Application for Licence Amendment

| Licence Number | L4247/1991/13 |
| Licence Holder | Talison Lithium Australia Pty Ltd |
| Premises | <p>Talison Lithium Mine</p> <p>Maranup Ford Road</p> <p>GREENBUSHES WA 6254</p> <p>Legal description –</p> <p>Mining tenements M01/3, M01/6, M01/7, M01/8, M01/9 and M1/16 L70/232 and L70/244 and General purpose lease G01/1 and G1/04</p> <p>As defined by the Premises maps in Schedule 1 and coordinates in Schedule 3</p> |

Figure 1: Groundwater monitoring bores

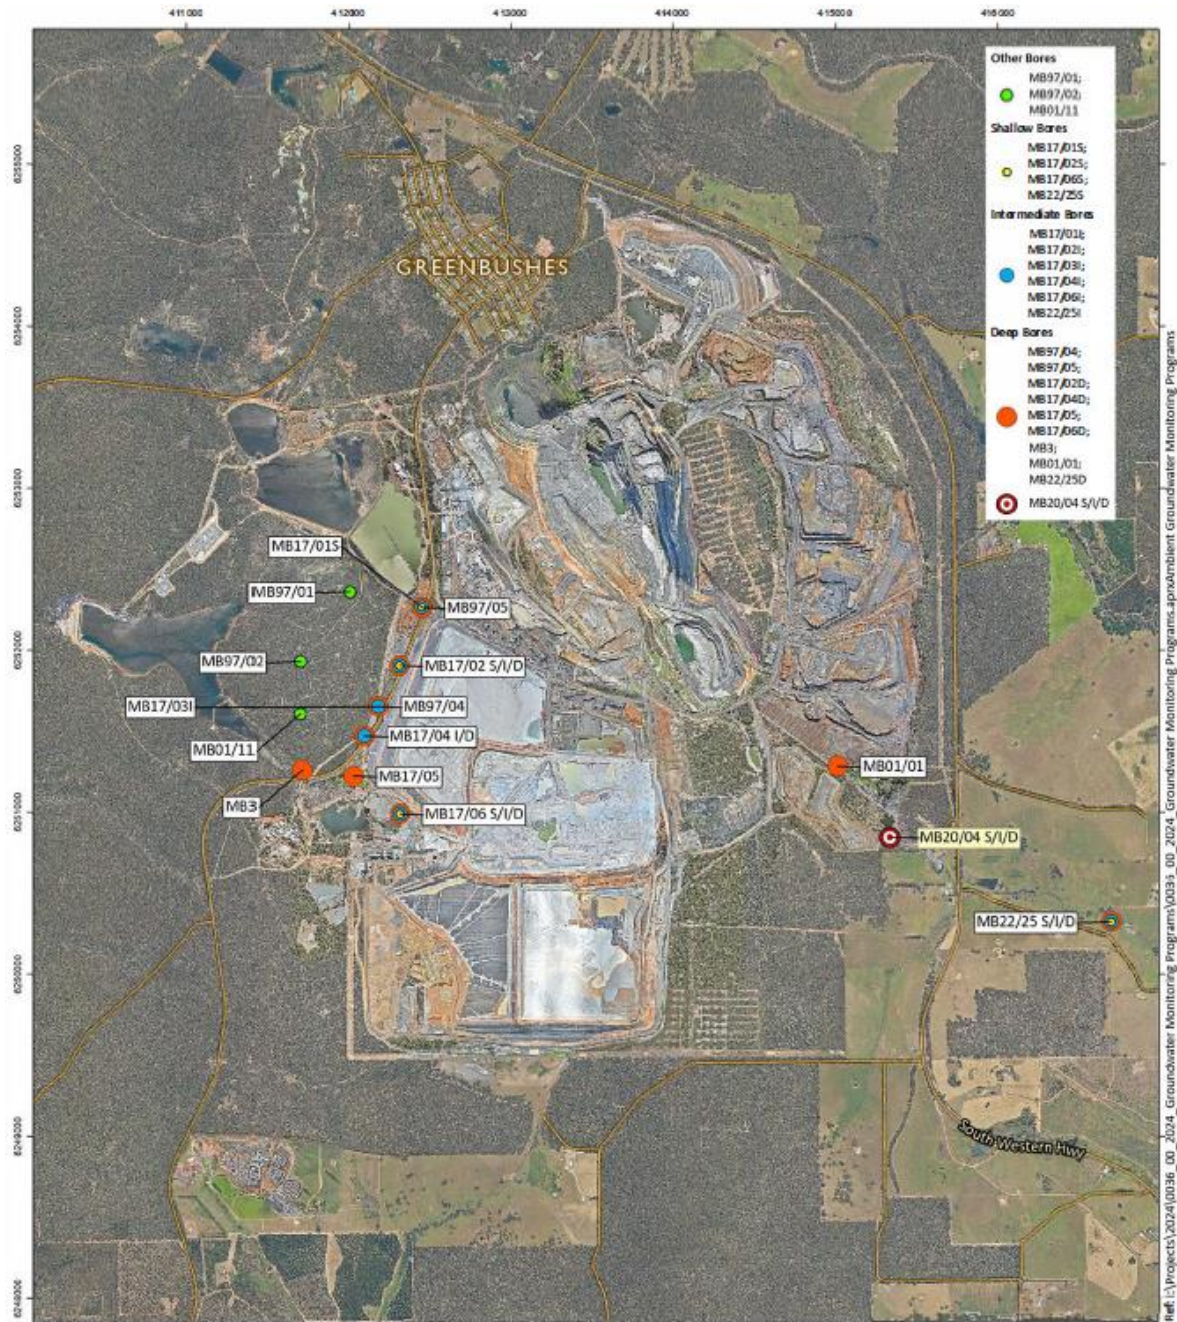
As part of this amendment application, the Licence Holder is requesting to remove a monitoring bore (MB01/01) from the groundwater monitoring program noting that the current location of the bore (as shown in Figure 1) will be destroyed with the expansion of the of the Floyds Waste Rock Landform (WRL). The Licence holder has advised that they have installed a replacement nested bore location (MB20/04), screened at three depths, located approximately 500 m southeast of the existing bore. They have advised that this bore location has been monitored quarterly since Q2 2024.

The Licence Holder was required to submit detailed information including evidence of the bore construction report for MB20/04 to demonstrate that it is fit for purpose / screened appropriately to groundwater monitoring. The Licence Holder has submitted a letter from an Engineering Geologist at PSM (PSM 2021) in lieu of a bore construction report for monitoring bore MB20/04. The letter included details on 10 existing TSF4 monitoring bore standpipes at four locations including MB20/04. MB20/04 hosts three multi-level standpipes monitoring bores denoted shallow (S), intermediate (I) and deep (D). The monitoring bores were reported to be in good condition (at the time of testing in April 2021), standpipes capped and protective covers secured.

Slug testing was carried out on MB20/04, where it was observed to have reached equilibrium above pre-testing dipped groundwater heads. PSM 2021, interpreted these results that the screen may be intersecting two varying lithologies; a higher permeability unit situated above a lower permeability unit.

From the information provided there is limited evidence to confirm with certainty that MB20/04 is a suitable replacement for MB01/01 or that it was screened appropriately. Monitoring data provided indicates that water quality between the two bores is similar, and the screening depths indicatively target varying lithologies. The delegated officer considers at this stage that MB20/04 will suit the purposes of providing ongoing groundwater quality information to replace MB01/01,

set to be destroyed with the expansion of the of the Floyds Waste Rock Landform (WRL). The delegated officer considers however, that a site wide assessment of the groundwater monitoring bores network, and their ongoing suitability is required in the future to ensure that premises wide monitoring bores remain fit for purpose, particularly as expansion activities impact existing monitoring locations.

| Condition no. | Proposed amendments |
|------------------------|---|
| Condition 30, Table 17 | Remove MB01/01 as the monitoring bore will be destroyed as part of the expansion of the Floyds Waste Rock Landform (WRL). This monitoring bore will be replaced with MB20/04. |
